REQUEST

Current Zoning: R-3 (single family residential)
Proposed Zoning: UR-2(CD) (urban residential, conditional) with five-year vested rights

Approximately 42.13 acres located on the south side of Hamilton Road, east of Steele Creek Road.
(Council District 3 - Mayfield)

The petition proposes to construct a 206-unit townhouse community on vacant acreage in southwest Charlotte at a density of 4.9 units per acre.

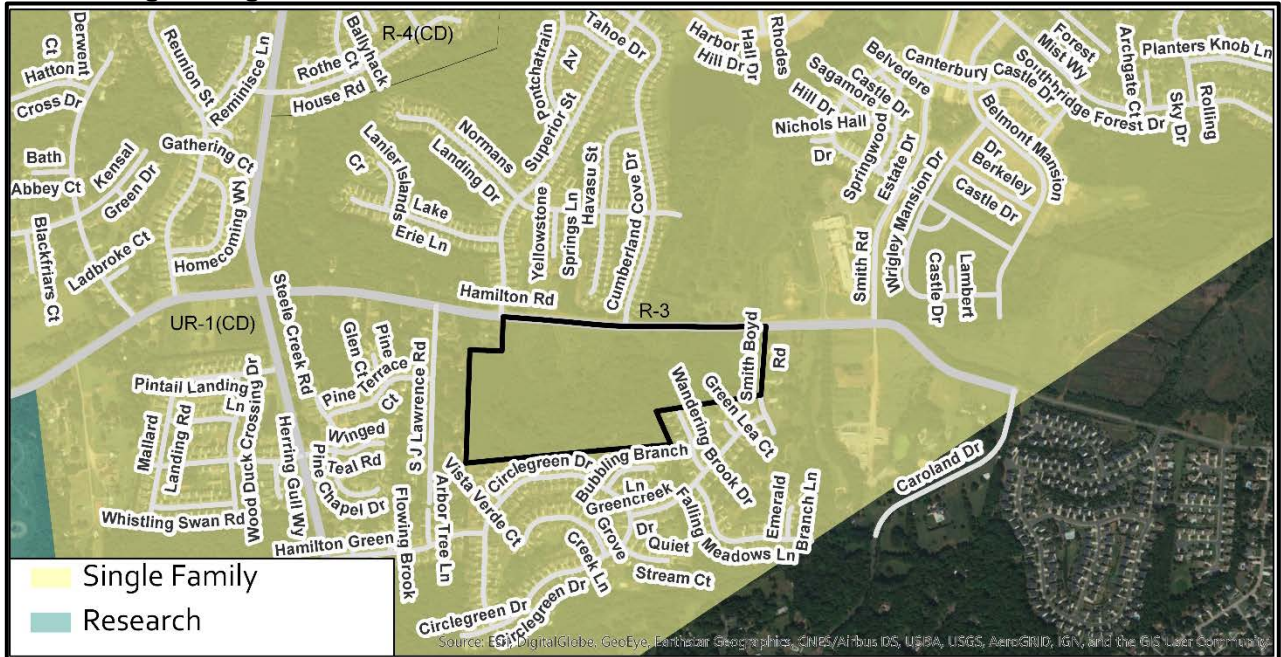
1. Show and label Potential 30-foot & 35-foot PCSO Stream Buffers per local GIS mapping data (Polaris, Charlotte Explorer, Virtual Charlotte) OR submit stream delineation report confirming buffer limits shown on rezoning plan (Please note: Stream Delineation Reports are subject to review and approval by Charlotte Storm Water Services.)
2. Add the following note under an Environmental Features heading: *Development within the SWIM/PCSO Buffer shall be coordinated with and subject to approval by Charlotte-Mecklenburg Storm Water Services and mitigated if required by City ordinance.*

3. Add a note limiting townhouse buildings to five or fewer individual units when fronting public or private network required streets.
4. Add a note committing to vary the number of individual units per building in adjacent buildings.

5. Revise site plan note III (2) to read "Site will be served by public and private streets".
-
